UNITED STATES PATENT AND TRADEMARK OFFICE

APPLICATION NO.	FILING DATE	FIRST NAMED INVENTOR	ATTORNEY DOCKET NO.	CONFIRMATION NO.
09/853,083	05/10/2001	Kenji Uchiyama	9319S-000204	5266

Office Action Summary

DETAILED ACTION

FIG. 6

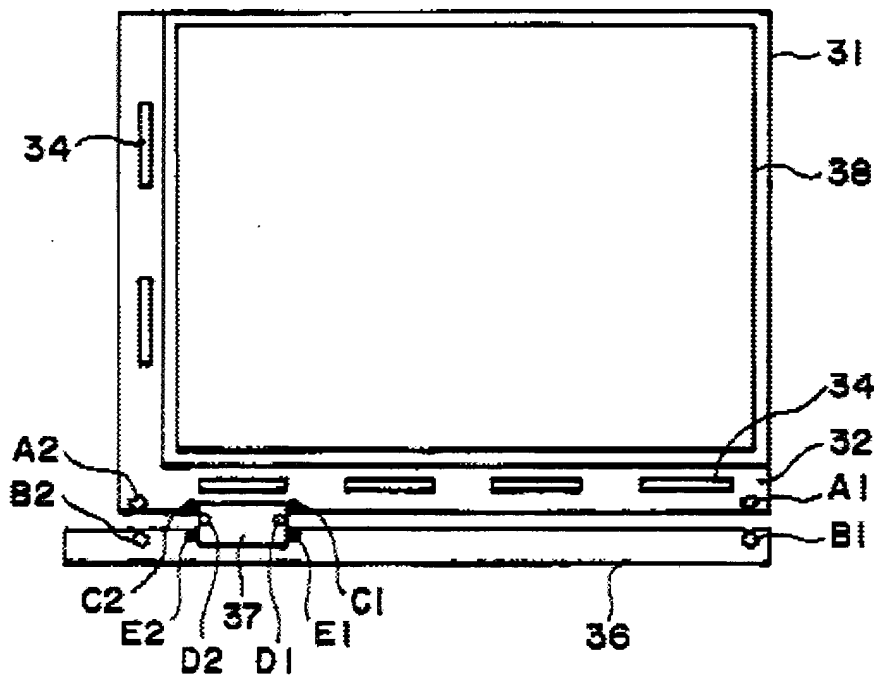
As to claims 1, 9, 11, 12, and 13, Takahashi discloses a method of manufacturing a liquid crystal apparatus (Applicant's electro-optical device) using substrate alignment marks, A1, A2, spaced approximately equal to the spacing of driver board (Applicant's mount base member) alignment marks B1, and B2, (Figure 6) (Applicant's plurality of second alignment marks being arranged at a spacing approximately equal to a spacing of the plurality of first alignment marks) to accurately align one set of terminals on said substrate with another opposing set of terminals on the driver board flexible film to facilitate thermal compression bonding.

Takahashi discloses the nature of the alignment problem, the dimensional change due to process heating, and decreasing the error by finely adjusting a size of a mask used in the electrode pattern formation (col. 1, lines 51-67, and col. 2, lines 1-48, especially col. 2, lines 29-39) so the pitches become substantially equal to each other during the bonding process (dimensional error reduced to acceptable magnitude which results in substantially equal pitch).

Takahashi does not explicitly disclose the mount base member having a linear thermal expansion coefficient that is larger than a linear thermal expansion coefficient of the substrate.

FIG. 1

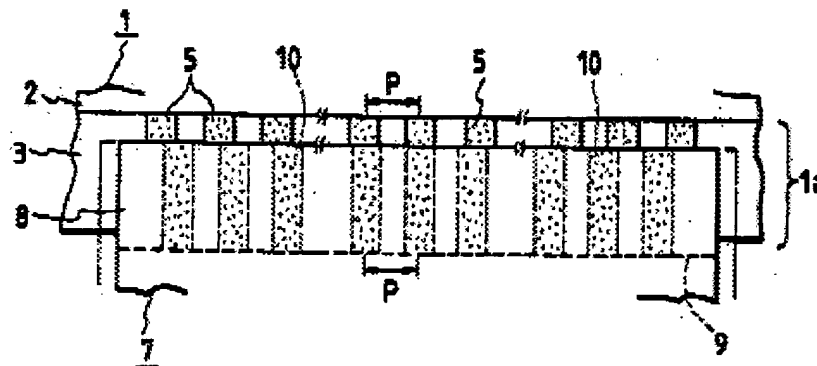
Ishikawa teaches the use of a flexible circuit board (Applicant's mount base member) with pitch $p=P/(1+\alpha)$ having a linear thermal expansion coefficient that is larger than a linear thermal expansion coefficient of the glass substrate by an amount related to α (Abstract, and Col. 4, lines 11-41) to ensure electrode terminals of the flexible circuit board and terminals of the glass substrate are connected to each other in a fully registered condition (Applicant's directly connects the first terminal bank and the second terminal bank, both of which become substantially equal to each other in pitch), and wherein the spacing of the alignment marks on the mount base member would necessarily be space more apart due to the linear thermal expansion coefficient that is larger than a linear thermal expansion coefficient of the glass substrate.

Ishikawa is evidence that ordinary workers in the art of liquid crystals would find the reason, suggestion, or motivation to add the use of a mount base member with pitch $p=P/(1+\alpha)$ having a linear thermal expansion coefficient that is larger than a linear thermal expansion coefficient of the glass substrate by an amount related to α to ensure the method directly connects the first terminal bank and the second terminal bank, both of which become substantially equal to each other in pitch.
